**Subject: Beaver Valley Power Station, Unit Nos. 1 and 2
BV-1 Docket No. 50-334, License No. DPR-66
BV-2 Docket No. 50-412, License No. NPF-73
Responses to a Request for Additional Information (RAI dated
September 30, 2005) in Support of License Amendment Request Nos.
302 and 173**

Non-Proprietary Responses to RAIs dated September 30, 2005

BEAVER VALLEY POWER STATION, UNIT NOS. 1 AND 2 (BVPS-1 AND 2)

EXTENDED POWER UPRATE (EPU)

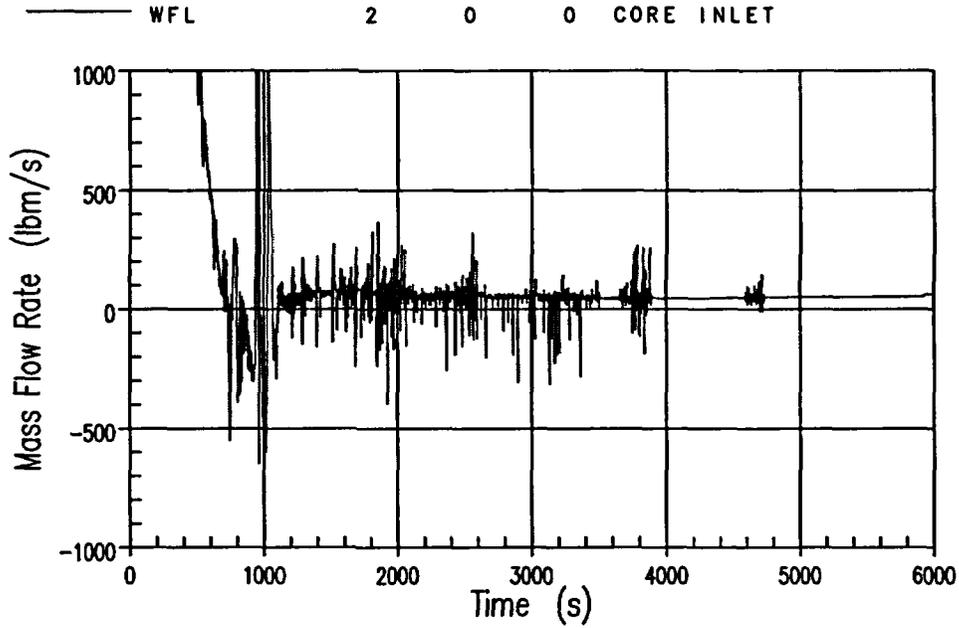
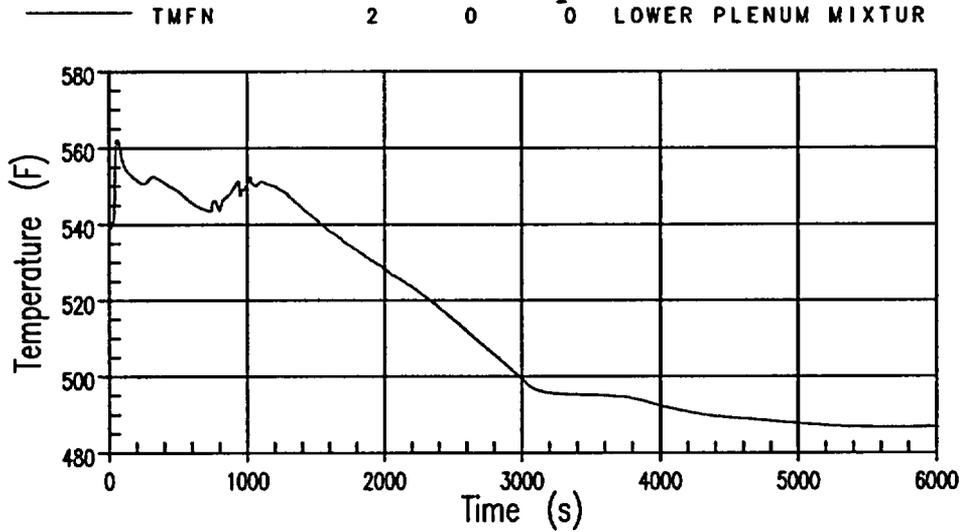
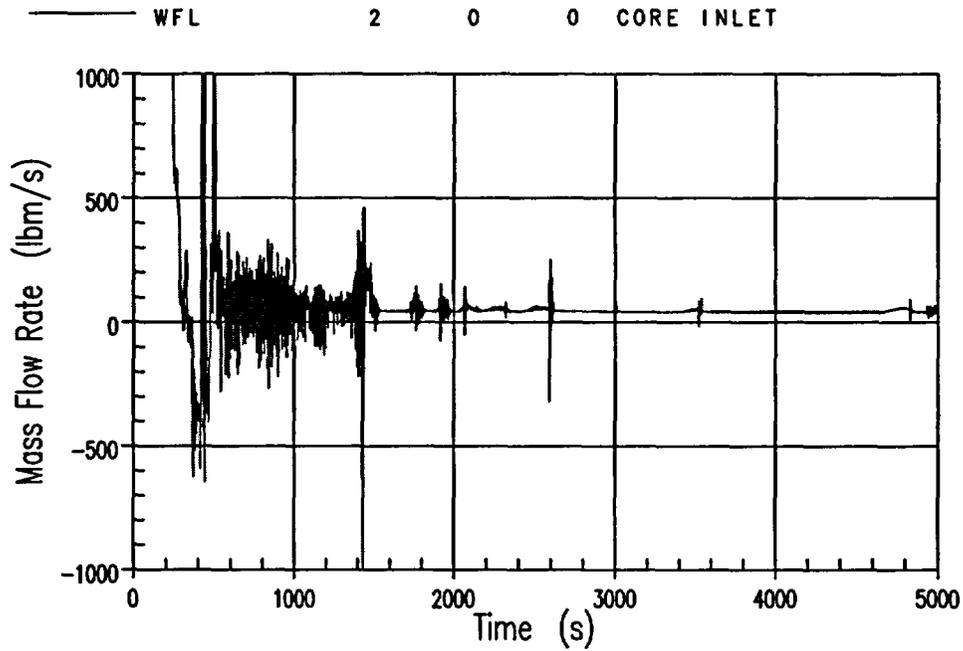
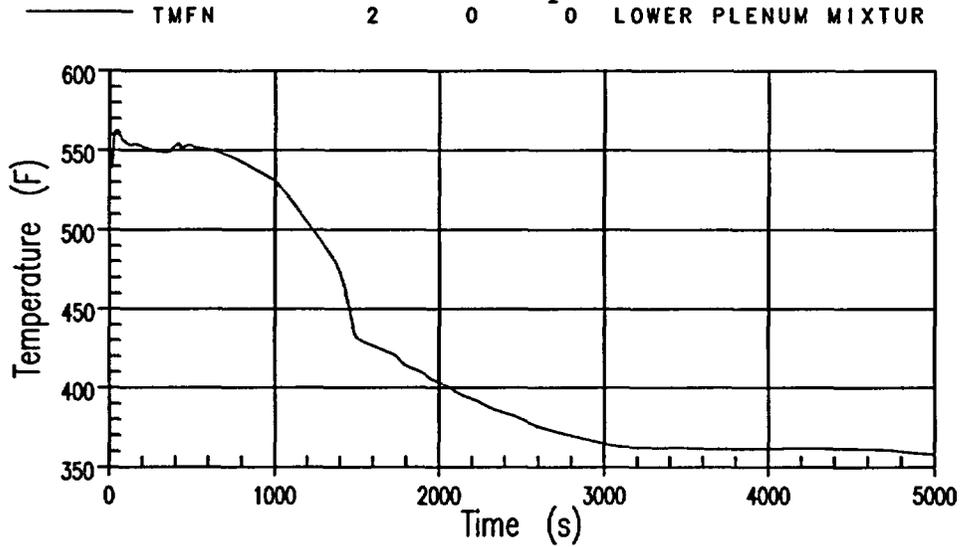
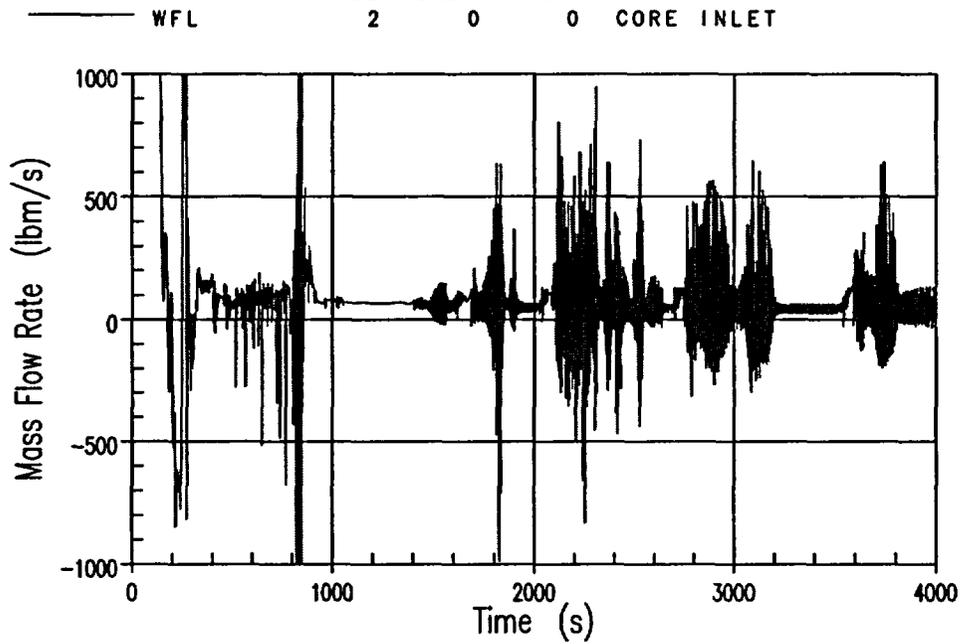
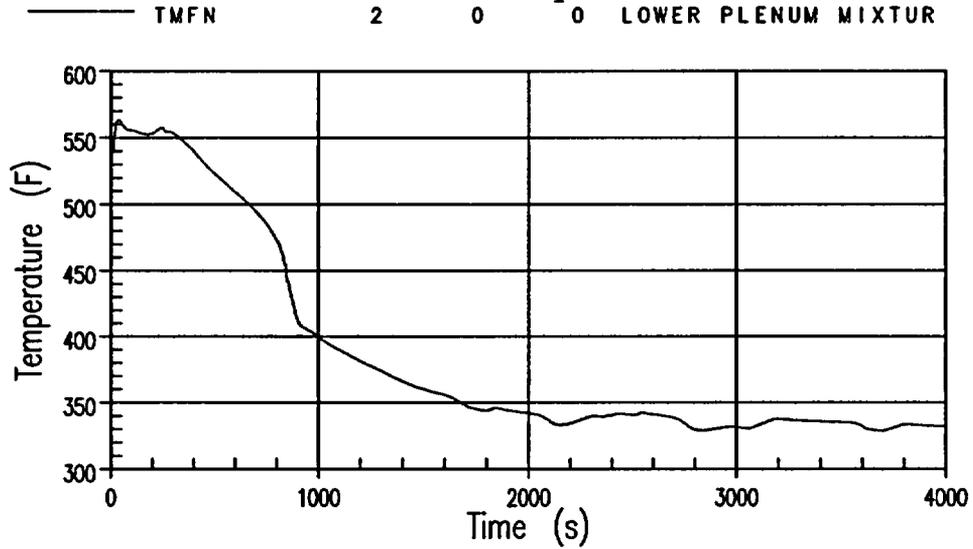
Please also provide the core inlet mass flow rate and inlet temperature vs. time for all breaks.

As requested, Figure E.13-12 through Figure E.13-25 present the core inlet flow and temperature plots for both BVPS-1 (Figure E.13-12 through Figure E.13-19) and BVPS-2 (Figure E.13-20 through Figure E.13-25).

Figure F-6 - Vessel Boric Acid Concentration for 120 psia RCS Pressure (BVPS-1)

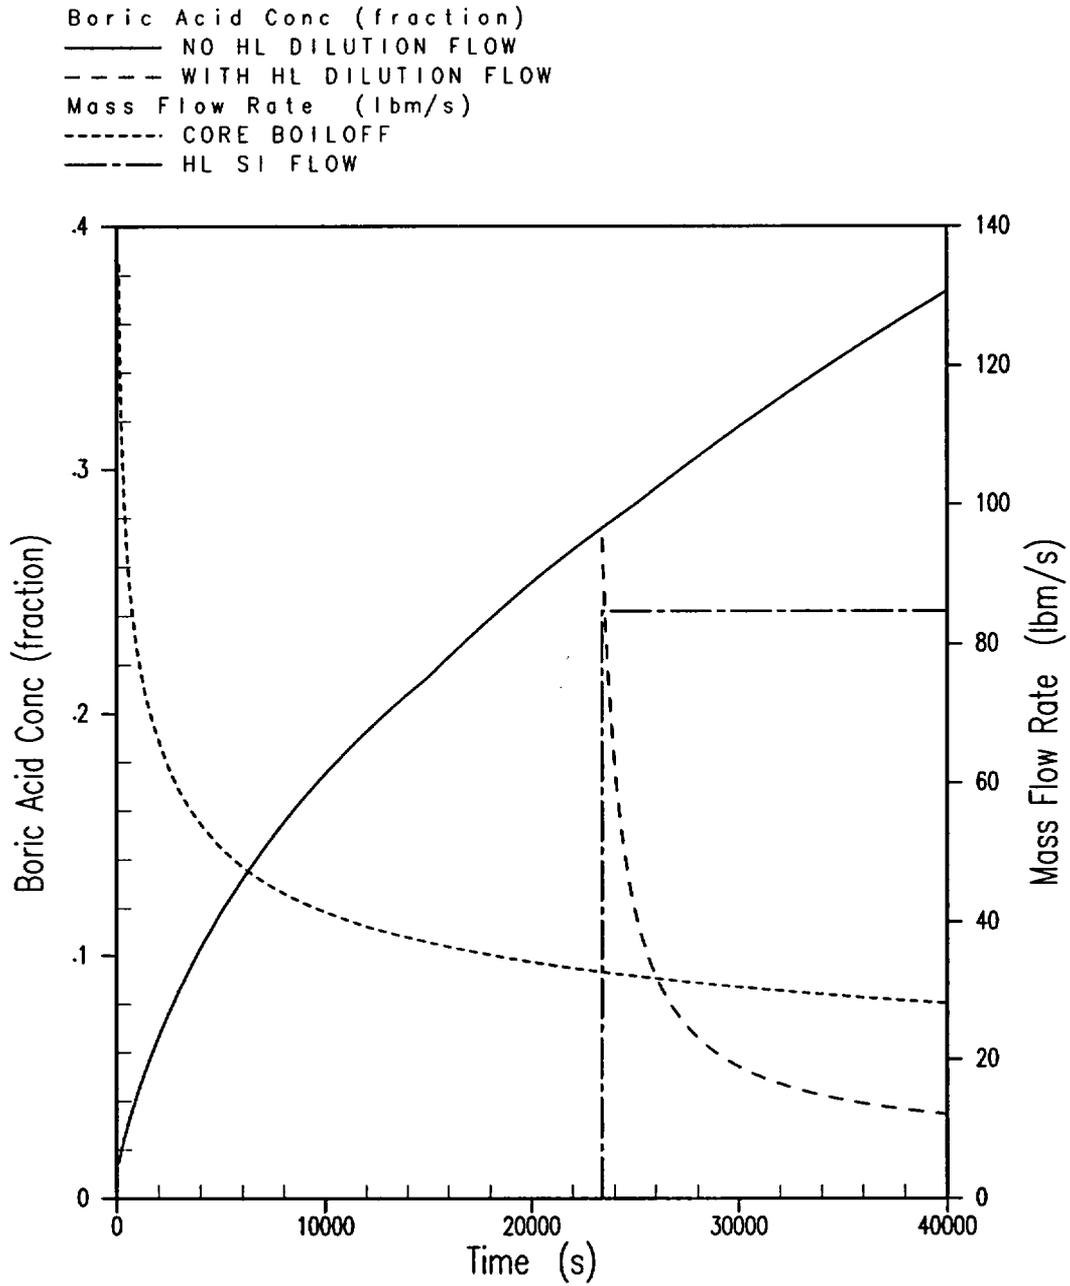
Please show that the boric acid concentration does not exceed 30 wt% for all small breaks where boiling occurs for extended periods of time. Also, steam exiting the two-phase surface in the core contains boric acid which can plate out on the spacer grids and the fuel alignment plate or any structures in the upper plenum, thus increasing the resistance to steam exiting the core. Please justify that boric acid plate-out does not increase the steam resistance in the loop and depress the two-phase level into the core. During condensation of the primary steam, can plate-out of boric acid block the steam generator tubes or increase the tube resistance? What happens to the boric acid after the steam condenses on the tube walls or any other structures in the loop? Please explain.

Small break LOCA scenarios were discussed in the response to Question F.6, and the core region boric acid concentration for a 120 psia small break LOCA scenario are presented in Figures F-6 and F-7. As seen in Figures F-6 and F-7, the boric acid concentration does not exceed 30 wt% for all small breaks even if cooldown is not considered. In reality, small break LOCAs would create significant less core boiloff than calculated since procedures to start reactor cooldown would be expected to occur within 1 hour after the accident. Such cooldown actions, if modeled, would introduce considerable margin in the calculation.
